UNITED STATES PATENT AND TRADEMARK OFFICE

APPLICATION NO.	FILING DATE	FIRST NAMED INVENTOR	ATTORNEY DOCKET NO.	CONFIRMATION NO.
09/800,006	03/06/2001	James C. Rush	STE01 P-1086	5256

Office Action Summary

DETAILED ACTION

FIG. 23
INVENTOR.
H. JONES

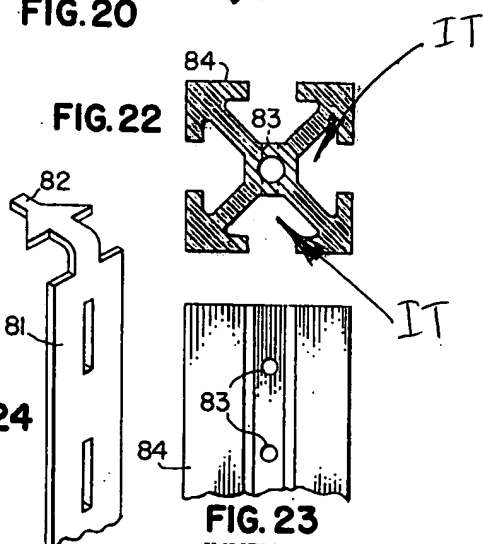
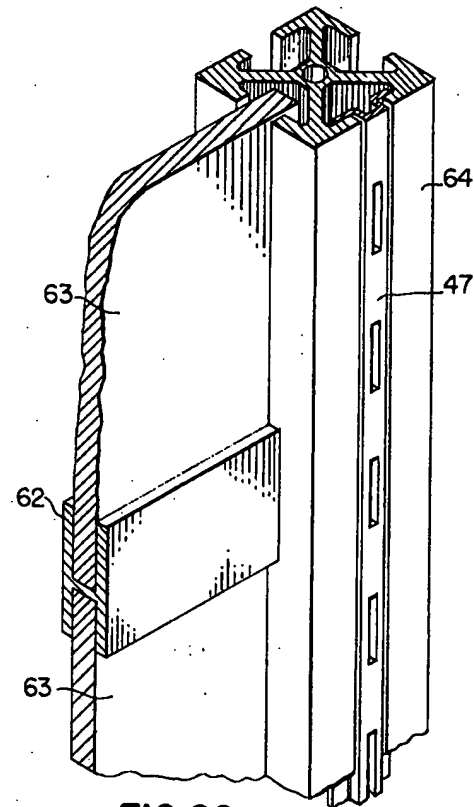
Claims 51-54 are rejected under 35 U.S.C. 102(b) as being anticipated by US Patent #3,513,606 to JONES. JONES discloses the use of a furniture system including a plurality of vertical posts (2) each having at least one vertical slot (colored yellow), a lower portion (18) abuttingly supported on a floor surface (F) and an upper portion connected to an associated plurality of overhead beams (36) by a plurality of beam-to-post connectors (4,5) attached at opposite ends of the beams and being detachable retained within the slots (colored yellow) of the posts (2). Regarding claim 52, the posts (2) extend vertically to an overhead beam (36) at an overhead position. In reference to claim 53, each beam (36) includes a hanger slot (36,37) extending longitudinally there along. Regarding claim 54, the hanger slot (36,37) supports furniture, column 7, lines 9-11 and see figure 25 showing a shelf (unlabeled).

FIG. 1

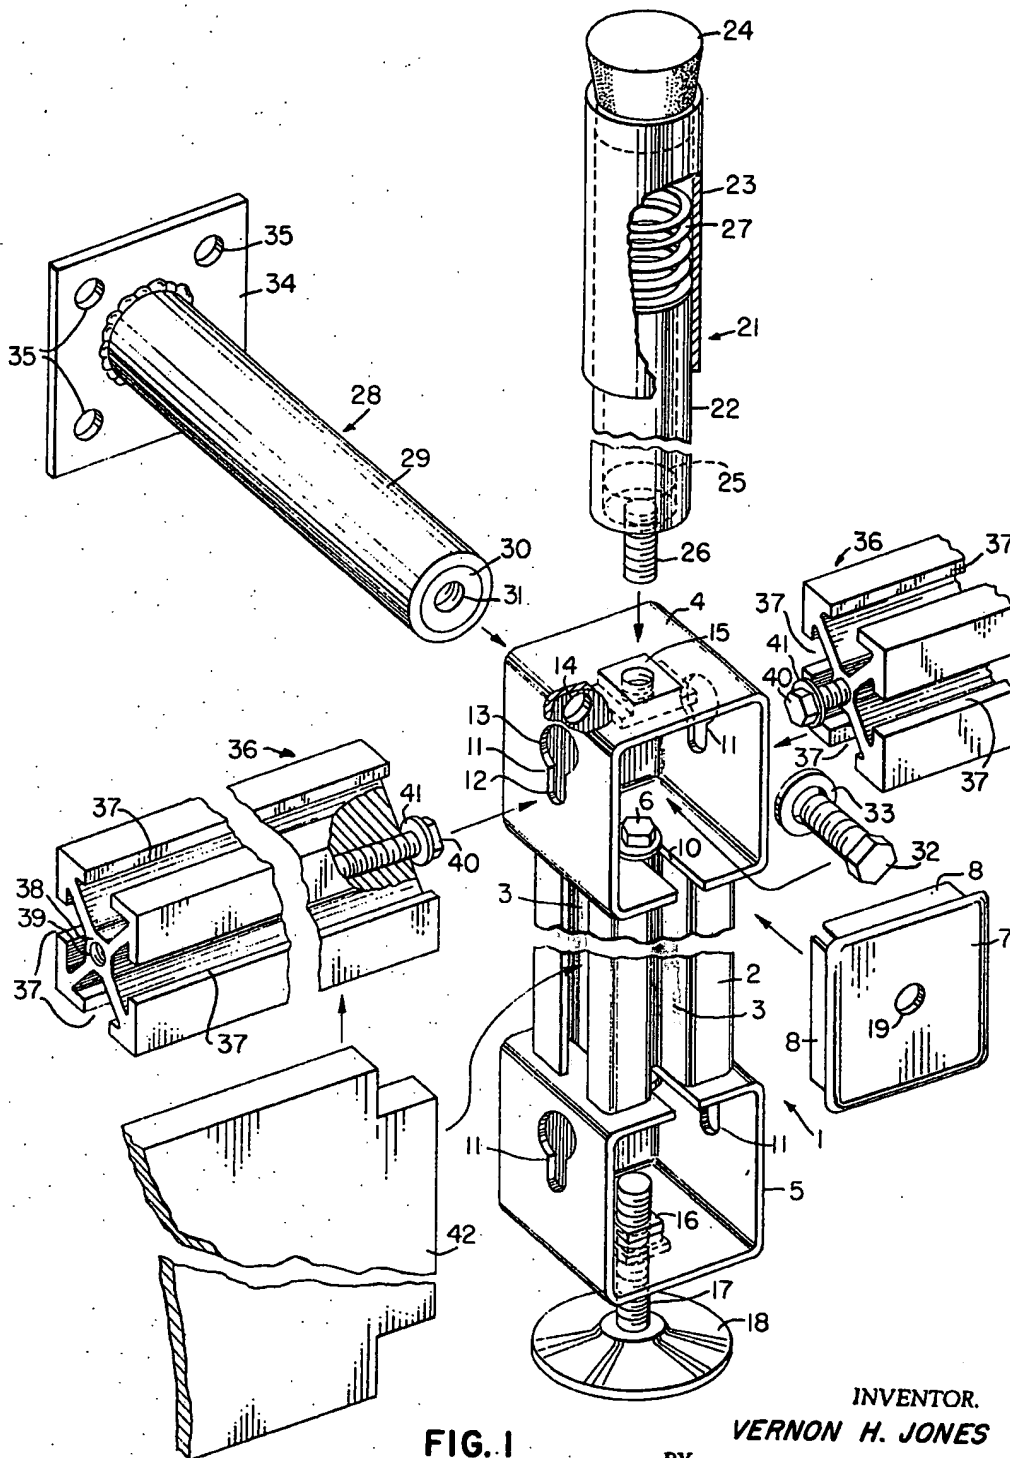
Claim 50 is rejected under 35 U.S.C. 102(b) as being anticipated by U.S. Patent #3,513,606 to JONES. JONES discloses the use of a furniture system including a plurality of vertical posts (2) each having a lower portion (18) abuttingly supported on a floor surface (F) and an upper portion connected to an associated plurality of overhead

beams (36); wherein the posts (2) include at least one X-shaped post (2) having four outwardly extending and mutually perpendicular flanges (colored red) having an end face (colored blue) including a single vertical slot (colored yellow) extending centrally there along. Each slot (colored yellow) has a general T-shape configuration with an enlarged interior track (IT) and a reduced neck portion (colored orange). The overhead beams (36) each have a lowermost face (colored blue) and an uppermost face (colored blue) both with a single, central, horizontal slot (37), see figure 1. The X-shaped post (2) further includes a hollow base (5) and a threaded shank (17) with adjustable leveling feet (18) that is inherently telescopingly received therein.

INVENTOR
ALAN CHARLES GOOSE

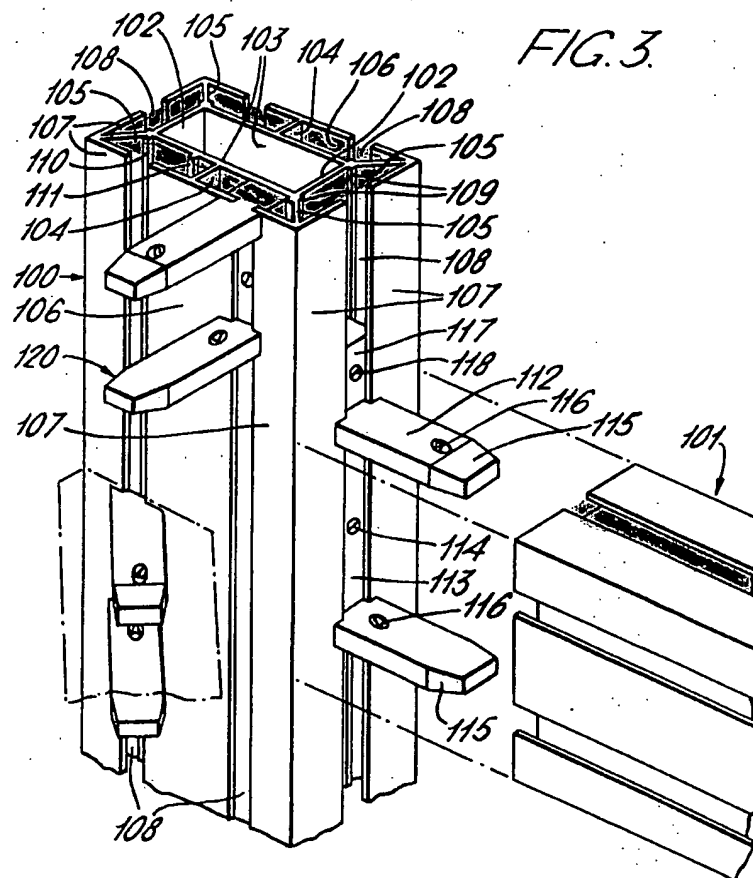
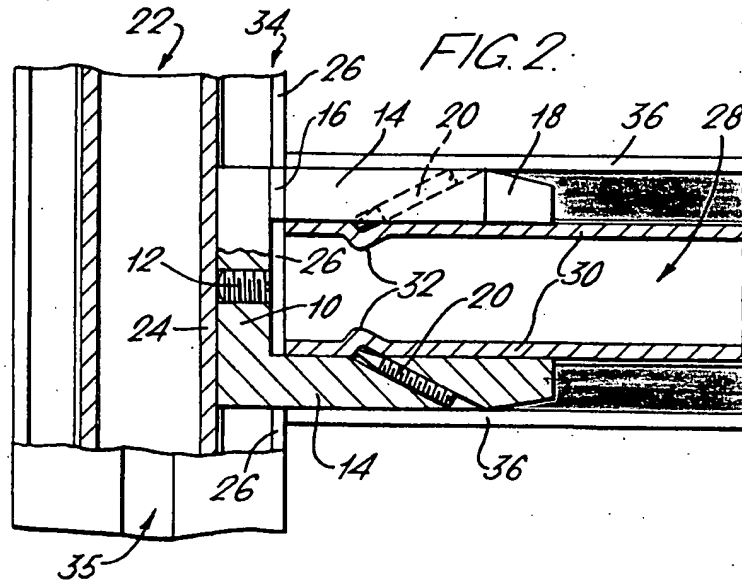
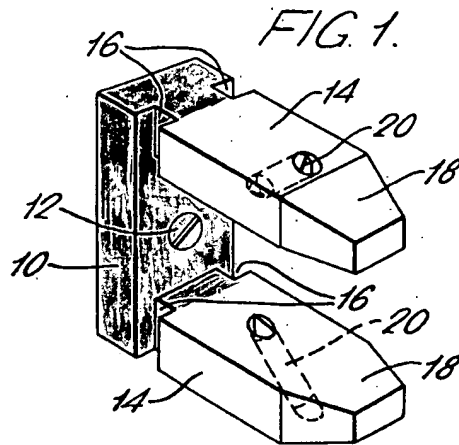
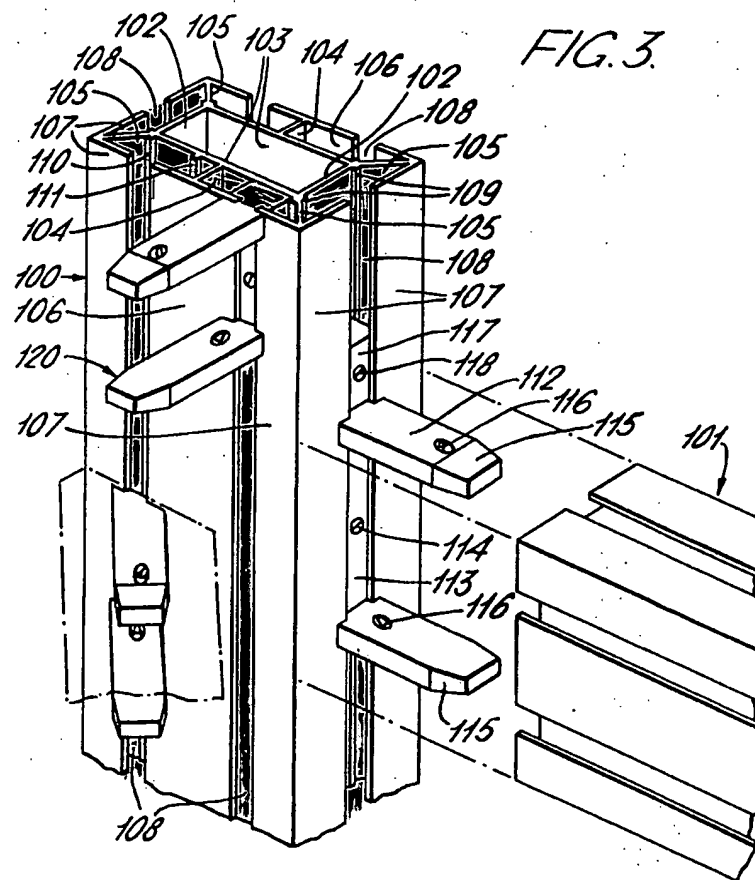
Claim 6 is rejected under 35 U.S.C. 103(a) as being unpatentable over US Patent #3,592,493 to GOOSE. GOOSE discloses the use of a furniture system including a plurality of overhead beams (101) having, respectively a single horizontal slot (108 and colored green) formed on an uppermost and a lowermost surface thereof wherein the overhead beams (101) are connected at opposite ends thereof to an upper portion of a plurality of vertical posts (100) such that a lower portion of the vertical posts are "adapted" to be supported by a floor surface (not shown), see figure 3. The vertical posts (100) include at least one outwardly extending flange (105) having an end face (107) with a generally T-shaped vertical slot (108) having an enlarged interior track portion (colored purple) and a reduced neck portion (colored orange) that opens outwardly wherein the slot (108) extends centrally along the end face (107). A plurality of beam-to-post connectors, as shown in figure 1, having an elongate T-shaped central portion (colored red) with upper/lower key portions (14) received in the slots (108 and colored green) of the overhead beams (101), see the marked attachment. GOOSE discloses the basic claimed furniture system except for explicitly detailing that his system is intended for use in an open office space. Although GOOSE does not explicitly disclose that his furniture system is intended for use in an open office space, it would have been obvious to one having ordinary skill in the art at the time the invention was made that the manner in which a device is intended to be employed does not

Claims 20,21,23 and 25 are rejected under 35 U.S.C. 103(a) as being unpatentable over US Patent #3,592,493 to GOOSE. GOOSE discloses the use of a furniture system including a plurality of overhead beams (101) having, respectively a single horizontal slot (108 and colored green) formed on an uppermost and a lowermost surface thereof wherein the overhead beams (101) are connected at opposite ends thereof to an upper portion of a plurality of vertical posts (100) such that a lower portion of the vertical posts are "adapted" to be supported by a floor surface (not shown), see figure 3. The vertical posts (100) include at least one outwardly extending flange (105) having an end face (107) with a vertical slot (108) that opens outwardly wherein the slot (108) extends centrally along the end face (107). A plurality of beam-to-post connectors, as shown in figure 1, are received in the slots (108 and colored green) of the overhead beams (101), see the marked attachment. GOOSE discloses the basic claimed furniture system except for explicitly detailing that his system is intended for use in an open office space. Although GOOSE does not explicitly disclose that his furniture system is intended for use in an open office space, it would have been obvious to one having ordinary skill in the art at the time the invention was made that the manner in which a device is intended to be employed does not differentiate the claimed apparatus from a prior art device satisfying the claimed structural limitations. Regarding claim 21, each of the slots (108) in the posts (100) and each of the slots (108 and colored green) in the beams (101) is similarly sized and shaped to receive a common fastener (14)

therein. In reference to claim 23, the posts (100) include at least one X-shaped post (100) having four outwardly extending and mutually perpendicular flanges (104,105) having an end face (106,107) including a single vertical slot (108) extending centrally there along. Regarding claim 25, each beam (101) having opposite side faces also having slots (108) wherein slots (108) can be hanger slots (108) extending there along. Claims 22 and 26 are rejected under 35 U.S.C. 103(a) as being unpatentable over US Patent #3,592,493 to GOOSE in view of US Patent #3,513,606 to JONES. GOOSE discloses the basic claimed device except for explicitly detailing that the system is configured to include a plurality of partition accessories. Although GOOSE is silent in this regard, JONES teaches that it is known in the art to provide a furniture system with a plurality partition accessories (67,81) each having portion; respectively, hook portions (77,82) detachably retained within slots (not labeled) formed in the posts (2,64,65) and beams (4). Hence, it would have been obvious to one having ordinary skill in the art at the time the invention was made to provide the system of GOOSE with the accessories of JONES in order to give the users with a wide variety of utensils needed to perform efficiently and properly.

Regarding claim 36, the uppermost face of the beam (101) of GOOSE also includes a horizontal slot (108 and colored green). In reference to claim 37, the slots (108) are generally T-shaped with an enlarged interior track portion (colored purple) and a reduced neck portion (colored orange), see the marked attachment. Regarding claim 38, the beam-to-post connectors, as shown in figure 1 of GOOSE, are shaped to be inserted into the open end (colored orange) of the slots (108). In reference to claim 39, each of the beam-to-post connectors, as shown in figure 1 of GOOSE, have an elongate T-shaped central portion (colored red) with upper/lower key portions (14) adapted for close reception into the slots (108 and colored green) in the uppermost/lowermost faces of the beams (101).
